## NOTICE OF INTEREST, BUILDING REQUIREMENTS, AND ESTABLISHMENT OF RESTRICTIVE COVENANTS

**LETTER**  
**ADDENDUM #1 AND REVIEW RESPONSE #1**  
**PROPOSED 6800 NORTH INDUSTRIAL/**  
**PROPOSED DEER PARK INDUSTRIAL**  
**1100 SOUTH 50 WEST**  
**AMERICAN FORK, UTAH**

Re: Letter  
Addendum #1 and Review Response #1  
Proposed 6800 North Industrial/Proposed Deer Park Industrial  
1100 South 50 West  
American Fork, Utah

## **3. TAYLOR GEOTECHNICAL (TG) REVIEW RESPONSE**

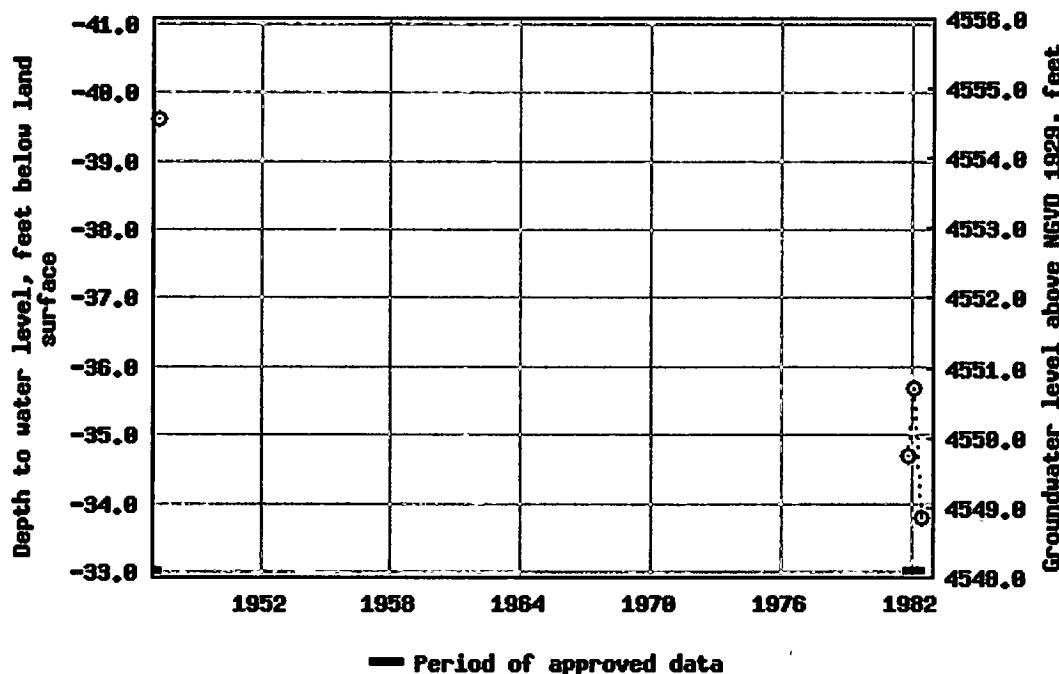
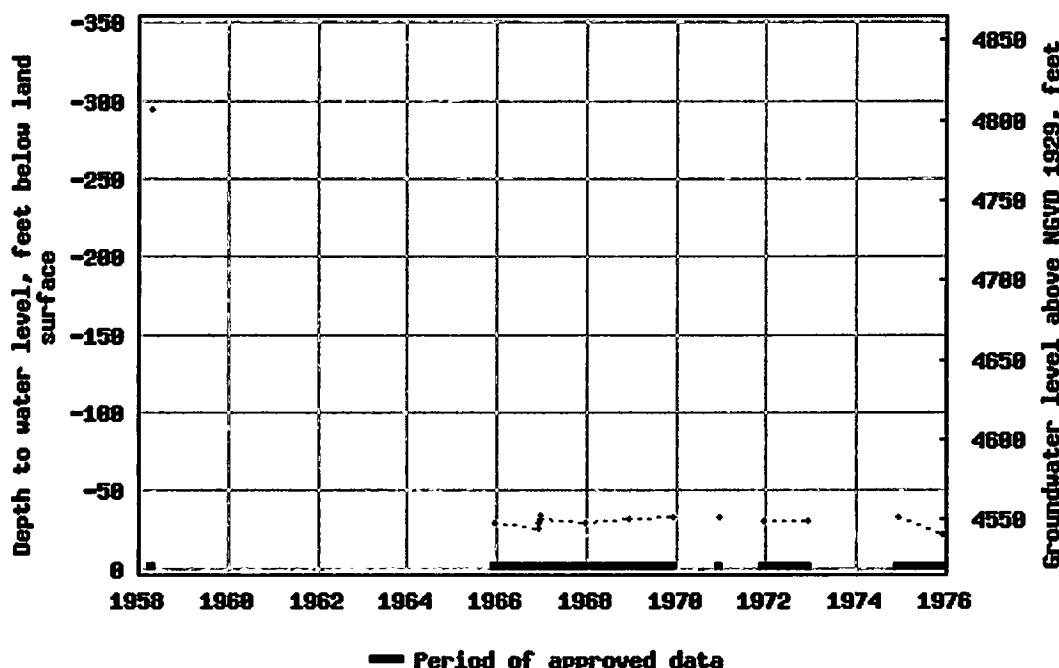
*Based on section 2-7-2 of the American Fork City Sensitive Land Ordinance, GSH should provide the historical high groundwater table for the subject site. TG recommends American Fork City request GSH provide the historical high groundwater table for the subject site and state the reference used.*

GSH utilized waterdata.usgs.gov to review the historical high groundwater table for the subject. Historical high groundwater tables in wells directly adjacent to the northwest and northeast indicated were recorded as shallow as approximately 33 feet below the ground surface.

The historical high groundwater tables are included in Attachment 5, Historical High Groundwater Tables. However, these levels are unrealistically low. GSH recommends designing to an anticipated groundwater elevation of 3.6 feet, 1 foot higher than what was measured in the original study.
